Department of Energy

January 5, 2011

Attachment 1
10-WTP-348

Panelist Additions to the Public Record Based on Commitments Made
During Testimony Provided at DNFSB Public Hearing Held on
October 7 and 8, 2010
48 Pages

Figure 3.4 Mass Fraction vs. Droplet Diameters for Sprays as a Function of Orifice Diameter and Upstream Pressure (Mishima, Schwendiman, and Ayer October 1978)

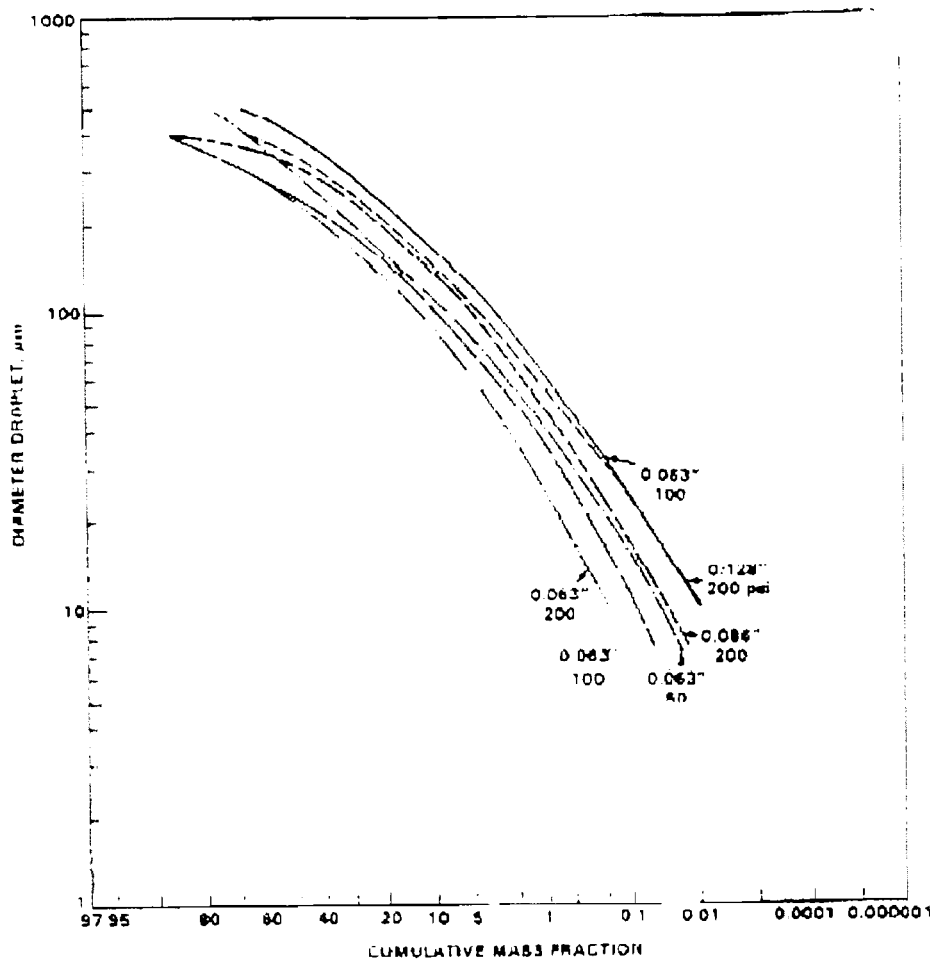
It is apparent from examination of Figure 3-4 on page 3-20 of the handbook that the bounding value of $1E-4$ [ARF][RF] does not bound all potential sprays from nozzles and therefore may not be bounding for metal vessels and piping. As illustrated in the figure and stated in the Handbook discussion, the size distribution of a spray formed by forcing liquid through a pressure nozzle/orifice becomes finer with decreasing size of the orifice and increasing pressure. The Handbook data and discussions were adopted from previous accident consequence studies for nonreactor nuclear facilities as discussed below.

- The Handbook recommended bounding [ARF][RF] of $1E-4$ of respirable droplets ($\leq 10\ \mu\text{m AED}$) is based on "the coarsest distribution generated by commercial spray nozzles shown in Figure 3-4." While the $1E-4$ value corresponds to discharge from a nozzle of 0.128" diameter and 200 psig, no specific recommendations regarding leak size and pressure was intended in the Handbook.
- The [ARF][RF] of $1E-4$ of respirable droplets was originally selected for the PNL/NRC evaluation of a seismic scenario in a specific facility, Babcock and Wilcox mixed oxide fuel fabrication, and was incorrectly labeled as a "spray release". The value is an estimate of the stable (post interaction and deposition) liquid aerosol in a glove-box based

- The Safety Survey guidance was shortly thereafter formalized into DOE-HDBK-3010 that included the commercial spray data for water (Figure 3-4) and recommended the 1E-4 as a bounding value for spray releases.

- Figure 3-4 shows that the size distribution of a spray formed by forcing liquid through a pressure nozzle/orifice becomes finer with decreasing size of the orifice and increasing pressure.
